<b>Product / Process Change Notification (PCN)</b>	
<input type="checkbox"/> Major Change <input checked="" type="checkbox"/> Minor Change	
<b>PCN Number:</b> PCN_WCAP-CSRF_20240621  <b>Affected Series:</b> WCAP-CSRF  <b>Affected Order Codes:</b> 885392050XX  <b>PCN Date:</b> 2024-03-21 (YYYY-MM-DD) <b>Effective Date:</b> 2024-06-21 (YYYY-MM-DD)	<b>Change Category:</b> <input type="checkbox"/> Equipment/Location <input checked="" type="checkbox"/> General Data <input type="checkbox"/> Material <input type="checkbox"/> Process <input type="checkbox"/> Product Design <input type="checkbox"/> Shipping/Packaging <input type="checkbox"/> Supplier <input type="checkbox"/> Software
<b>Contact:</b> Product Management <b>Phone:</b> +49 (0) 7942 - 945 5001 <b>Fax:</b> +49 (0) 7942 - 945 5179 <b>E-Mail:</b> pcn.eisos@we-online.com	<b>Datasheet Change:</b> <input checked="" type="checkbox"/> Yes <input type="checkbox"/> No  <b>Attachment:</b> <input type="checkbox"/> Yes <input checked="" type="checkbox"/> No

<b>Description of Change:</b> Because of a database mismatch, Würth Elektronik will update the packaging specification in the datasheets for 14 order codes of WCAP-CSRF series. This is a

**Packaging Specification - Tape and Reel: [mm]**

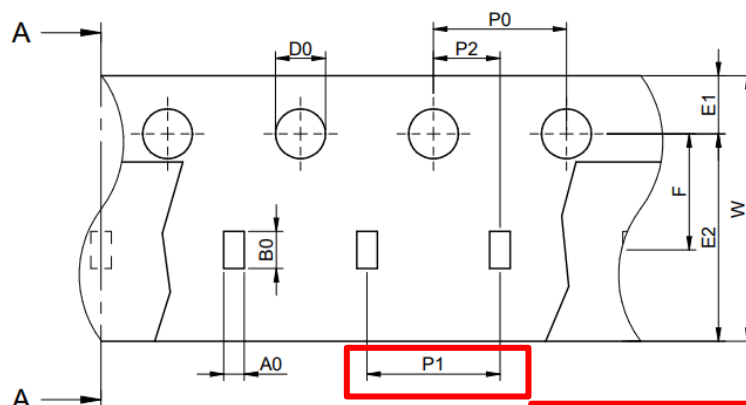
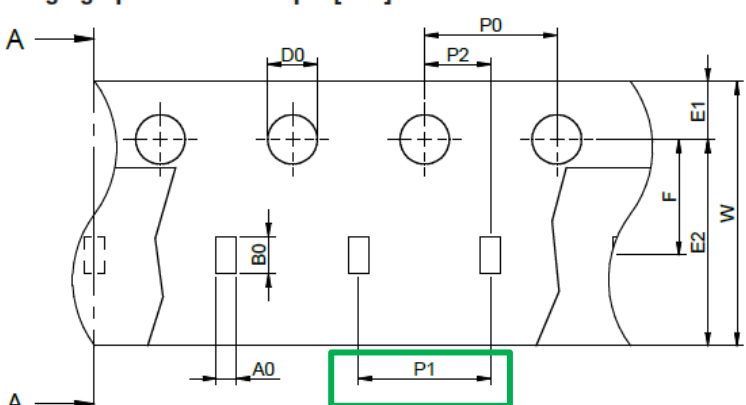
Corrected dimensions and tolerances are marked with a red box **before change** and green box **after change**.

A0	B0	W	T	T1	P0	P1	P2
<b>tolerance</b>	typ.	typ.	+0,3/ -0,1	ref.	max.	±0,1	±0,1	±0,05
<b>value</b>	0,70	1,20	8,00	0,80	0,10	4,00	4,00	2,00

Tape Type	A0 (mm)	B0 (mm)	W (mm)	T (mm)	T1 (mm)	P0 (mm)	P1 (mm)	P2 (mm)
	typ.	typ.	+0,3/ -0,1	ref.	ref.	±0,1	±0,05	±0,05
1a	0,40	0,70	8,00	0,55	0,10	4,00	2,00	2,00
